# Technical Service Bulletin

## 69 Seat belts retract slowly

69 22 82 2015765/6 February 17,2022. Supersedes Technical Service Bulletin Group 69 number 10-04 dated May 25, 2010, for reasons listed below.

Model(s)	Year	VIN Range	Vehicle-Specific Equipment
TT Roadster	2007 – 2009	All	Not Applicable
	2010	000001 – 007076

Figure 1. The seat belt guides (7).

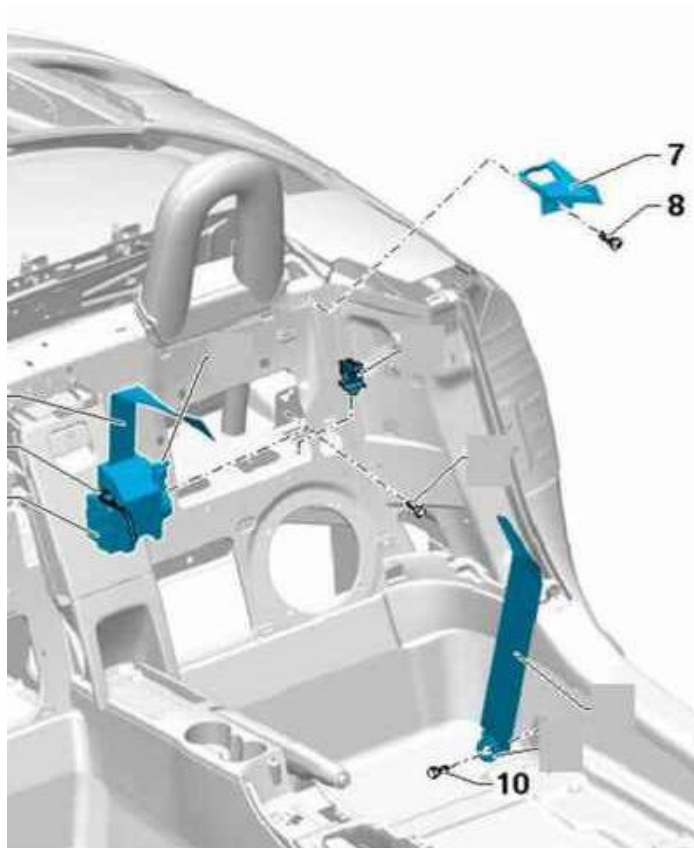
Routing and retraction force of the seat belt changed to improve the retraction and the belt guide has improved clearance for the belt webbing.

Also replace both the left and right belt guides (Figure 1, Point 7) with left belt guide **8J7 857 795 C 4PK** and right belt guide **8J7 857 796 C 4PK** according to the repair procedure in *ElsaWeb* >> *Body* >> *Body Interior* >> *69 Passenger Protection, Airbags, Seat Belts* >> *Seat Belts, Roadster*.

Replace the left three point seat belt with part number **8J7 857 705 M + color code**. Replace right three point seat belt with **8J7 857 706 M + color code**.

Replace both the left and right belt guides (Figure 1, Point 7) with left belt guide **8J7 857 795 C 4PK** and right belt guide **8J7 857 796 C 4PK** according to the repair procedure in *ElsaWeb* >> *Body* >> *Body Interior* >> *69 Passenger Protection, Airbags, Seat Belts* >> *Seat Belts, Roadster*.
